TECHNICAL INFORMATION

- Subject** ▶ Modifications of 1) Gear Housing Cover and 2) Insulation Cover
- For Models** ▶ JR3030, JR3030T
- Country** ▶ All countries except the following ; Canada, Mexico, U.S.A.
Australia, New Zealand
- Description** ▶ The parts in the subject have been modified as illustrated below.

1) Gear Housing Cover (JR3030 only)

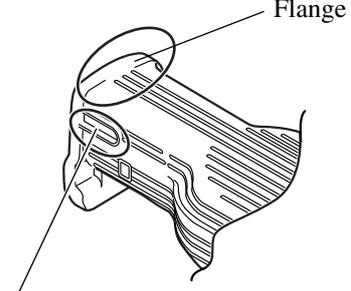
▶ Current	▶ New
JR3030	 Part No.317139-5	 modified Part No.317394-9

2) Insulation Cover

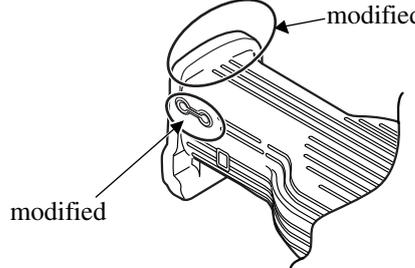
▶ Current	▶ New
For JR3030 & JR3030T Part No.421665-9 	For JR3030 Part No.421759-0  <ul style="list-style-type: none"> ● The flange at the top of Insulation cover has been enlarged in height.
	For JR3030T Part No.421760-5  <ul style="list-style-type: none"> ● The flange at the top of Insulation cover has been enlarged in height. ● The slit for hex. wrench has been modified.
